Site Development Plan.pdf Markup Summary

[1] S-1 Site Development Plan (9)

Subject: Callout
Page Label: [1] S-1 Site Development Plan
Author: dsdparsons

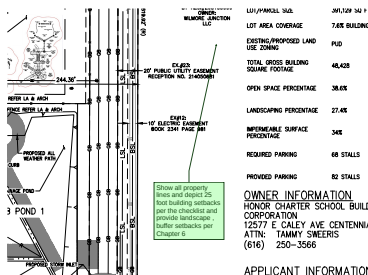
Add trash enclosure detail; it must be 100% enclosed with CMU, concrete, stucco to this set.

TRASH ENCLOSURE DETAILS HAVE BEEN ADDED TO THE SET. ADDITIONAL DETAILS ARE ALSO INCLUDED IN THE ARCHITECTURAL SET AND ARE REFERENCED ACCORDINGLY.

Subject: Text Box
Page Label: [1] S-1 Site Development Plan
Author: dsdparsons

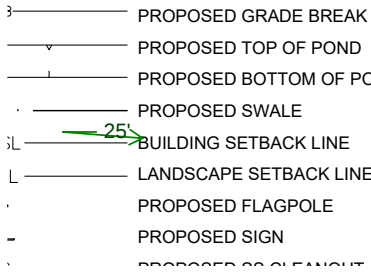
Please consider relocating this trash facility away from the residents and please meet the 25 setbacks as required.

TAIT RESPONSE:
TRASH ENCLOSURE HAS BEEN ROTATED AND MOVED OUT OF THE 25' BUILDING SETBACK.

Subject: Callout
Page Label: [1] S-1 Site Development Plan
Author: dsdparsons

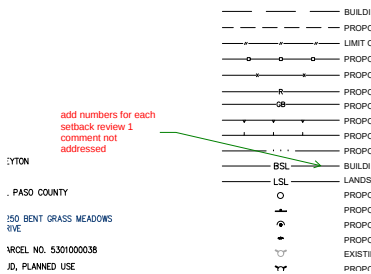
25'

TAIT RESPONSE:
SETBACK LINES HAVE BEEN LABELED ACCORDINGLY. ("25' BSL", "15' LSL").

Subject: Callout
Page Label: [1] S-1 Site Development Plan
Author: dsdparsons

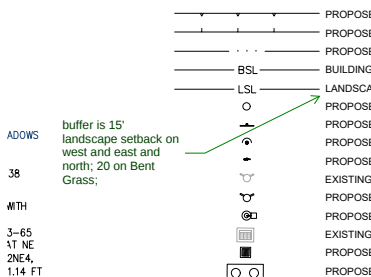
add numbers for each setback review 1 comment not addressed

TAIT RESPONSE:
SETBACK LINES HAVE BEEN LABELED ACCORDINGLY. ("25' BSL", "15' LSL").
